Application reference: 21/2940/PS192 SOUTH TWICKENHAM WARD

L-shape rear dormer roof extensions.

Project Officer Report

Volume Calculation provided by the agent

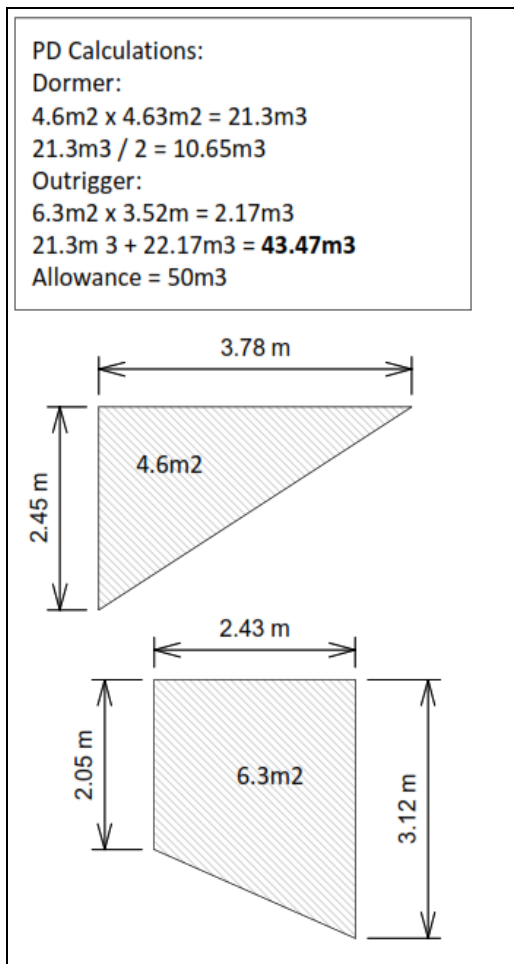
(d) The cubic content of the resulting roof space would exceed the cubic content of the original roof space by more than - (i) 40 cubic metres in the case of a terrace house (ii) 50 cubic metres in any other case	Compliant. See the end of this report.

The above volume calculation has been checked by the Planning Officer and has found to be correct.
